Re: Written Argument of Joe Bundrant in Support of Hearing Examiner's Amended Decision
Reference: File No's. 11-101457 LU/VAR, 11-101461 SM, 11-101464 RC, 11-101008
LDA, & 11-101007 SP

Re: Point Wells Development Public Comments
Reference: File No: 11 101457 LU, et. al.

Re: Comments on the Scope of the Environmental Impact Statement for the Point Wells Development, File Nos. 11-101457; 11-101461 SM; 11-101007 SP; 11-101008 LDA; and 11-101464 RC

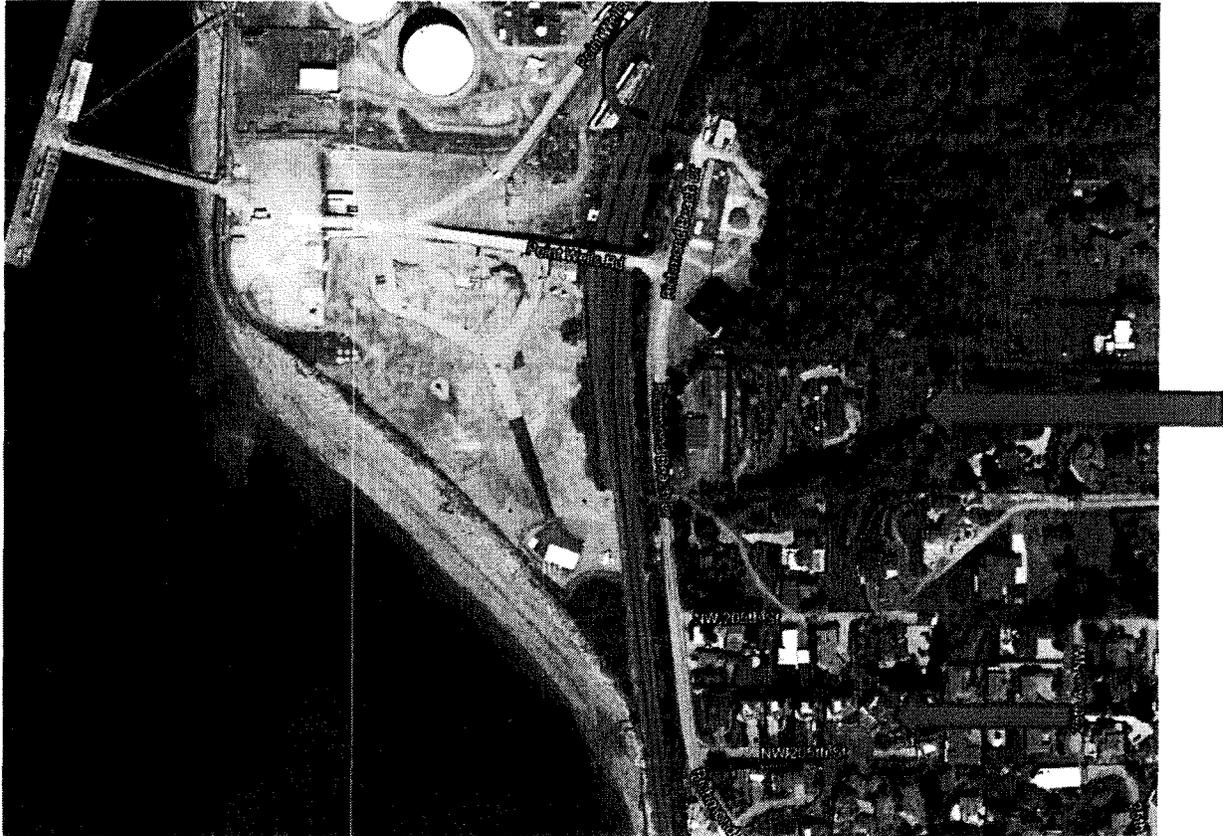
PDS should require the applicant to update and resubmit its SEPA checklist prior to proceeding with SEPA scoping for the Project. The applicant’s SEPA checklist, dated February 2011, is outdated. And considering the current proposal before PDS, it is an inadequate base from which to conduct the full environmental analysis that is required for the Project. To give one example,

note the following aerial view of the Project, which was provided by the applicant in the initial SEPA checklist for the Project:

The area surrounding the Project site has changed since 2011 and the SEPA checklist does not take these changes into account. Notably, the Bundrants' home is located in the area indicated by the red arrow in the graphic above, but does not appear in the above map. Nor does it show the numerous houses that are located to the southeast of the Project site—all of which can be seen in the following aerial photo, which we accessed through Google Maps several days ago. In the following graphic, the location of these residences is indicated with red arrows.

The Project will have significant adverse impacts on all of these properties, and these impacts must be taken into account in the DEIS for the Project. The view impacts alone deserve particular attention, as the Project could nearly eliminate the view of the Sound and the Olympics for many of these owners. These impacts are not acknowledged or discussed in the SEPA documents provided for the Project. Notably, some of the buildings in the Project (specifically, those identified as SV-T 3 through 5 in the Project documents) are slated to be eight to twelve stories tall, and will tower over nearby homes—possibly as much as 120 feet. Yet, the applicant's View Impact analysis does not acknowledge this impact, or present a cross-section showing the relative heights of development for this location.⁵ PDS must conduct a thorough view impact analysis as part of the DEIS, and should not rely on the limited information provided in the SEPA Checklist for the Project.
